Subject: VIRGIL C. SUMMER NUCLEAR STATION (VCSNS) UNIT 1  
DOCKET NO. 50-395  
OPERATING LICENSE NO. NPF-12  
RELIEF REQUEST RR-4-07 REQUEST TO USE ALTERNATIVE ROOT  
MEAN SQUARE (RMS) DEPTH SIZING REQUIREMENTS - RESPONSE  
TO REQUEST FOR ADDITIONAL INFORMATION

**VCSNS RESPONSE TO REQUEST FOR ADDITIONAL INFORMATION**

REQUEST FOR ADDITIONAL INFORMATION  
ALTERNATIVE REQUEST  
DEPTH SIZING ROOT MEAN SQUARE ERROR CRITERIA  
VIRGIL C. SUMMER NUCLEAR STATION, UNIT NO. 1  
DOCKET NUMBER 50-395

Schematic Representation of Original Design Geometry of the Loop Cold Leg Nozzle to Elbow Weld

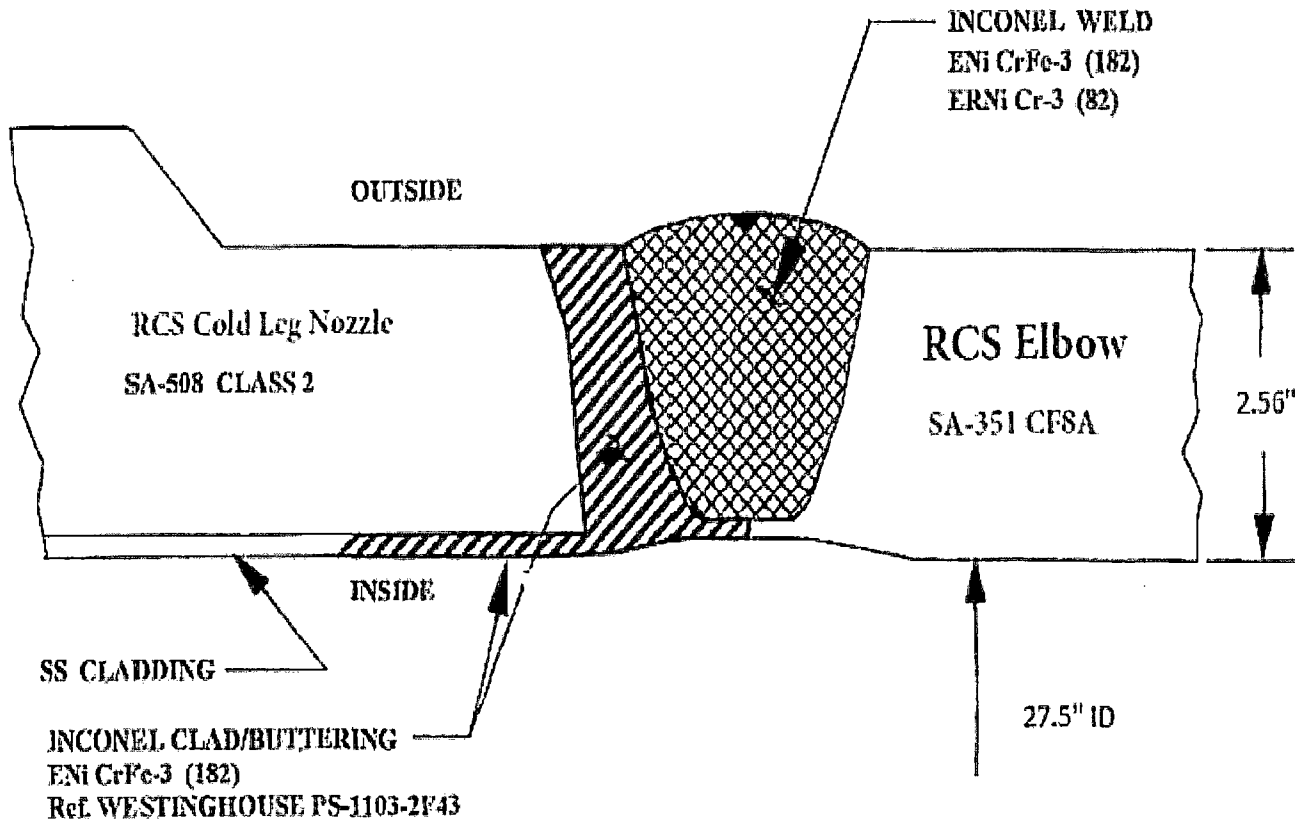
- (a) Provide materials of construction for the subject pipes, elbows, and welds.
- (b) Provide dimensions (e.g., wall thickness and diameter) for the subject welds.
- (c) Provide a sketch of the welds.

*VCSNS has supplied the weld information in Attachment 2.*

- (a) *The materials of construction can be found on Page 2 of Attachment 2.*
- (b) *The dimensions of the welds can be found on Page 3 of Attachment 2.*
- (c) *Page 2 and 3 both provide sketches of the subject welds.*
